Technical BULLETIN

SAFETY RECALL

CERTAIN 2019 YZFR3AK (YZF-R3 ABS) MODELS FACTORY MODIFICATION CAMPAIGN – Brake Hose Holder Comes Off

A. Brake Hose Inspection

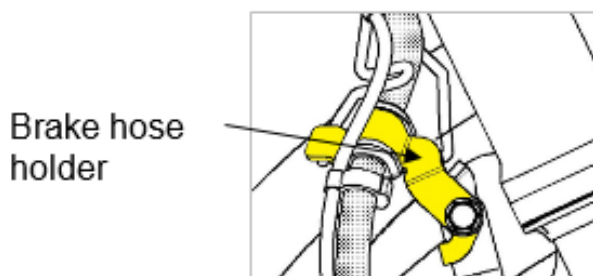
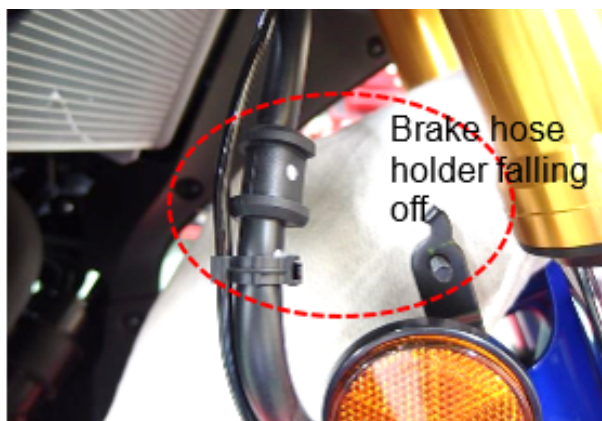
1. Check the brake hose holder is missing. If so, check the brake hose protector thoroughly for wear or damage.

If there is no wear or damage, replace the front brake hose holder.

If there is damage, refer to the service manual (p/n LIT-11616-32-26) to replace the brake hose before beginning this modification. Remember to check for wear from the horn lead wire per Technical Bulletin M2020-001R at the same time.

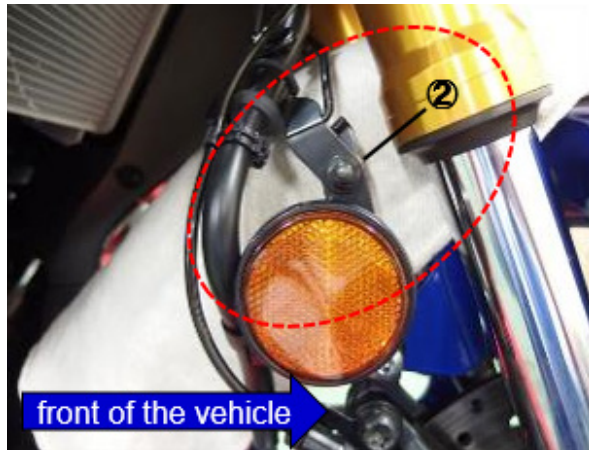
2. Remove the brake hose clamp (1) next to the reflector. The clamp will be reused.

Remove the projection from the front of the reflector bracket.

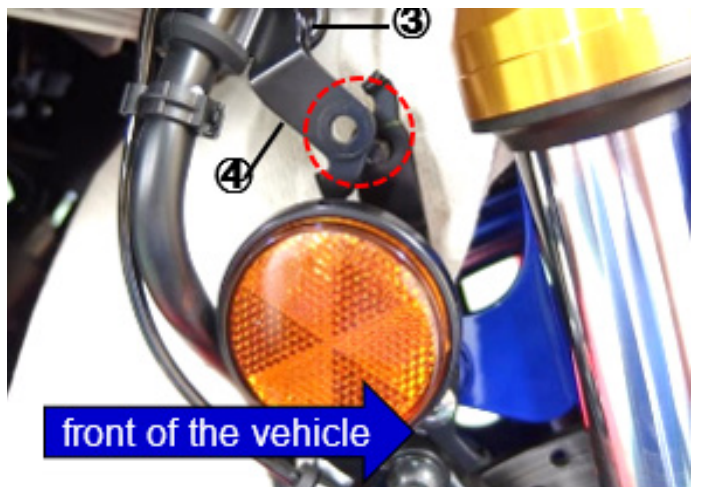
3. Remove the front brake hose holder nut (2) and remove the brake hose holders (3) and (4).

4. In reverse order of removal, replace brake hose holders (3) and (4) with new ones. included in the modification kit. Be sure to hook the tab of the holder (4) and the window of holder (3).

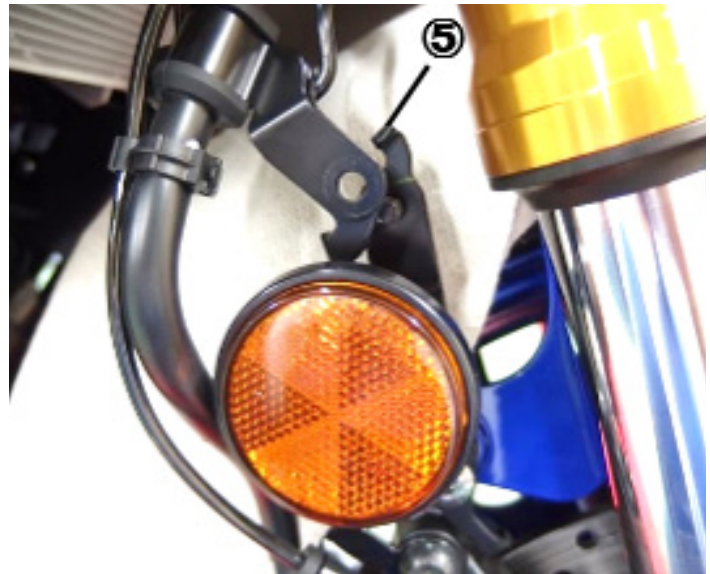
- Attach the brake hose holders (3) and (4) assembled in the reflector bracket (5). Hook the holder (4) on the projection of the reflector bracket. Be sure the holder (4) is flush against the reflector bracket tab (5).

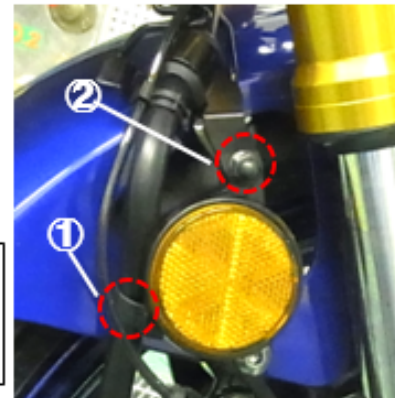
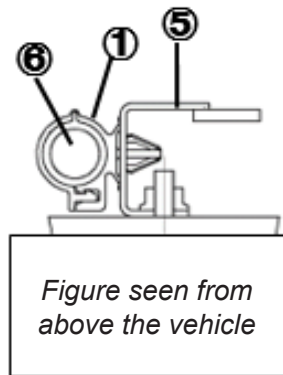
- Install the brake hose holder nut (2) and tighten to the specified torque of **6.5 - 7Nm (0.65 ~ 0.70 m-kg, 4.8 ~ 5.2 lb-ft)**.
- Clamp the brake hose (6) and install the projection of the clamp (5) to the hole of the reflector bracket (1).
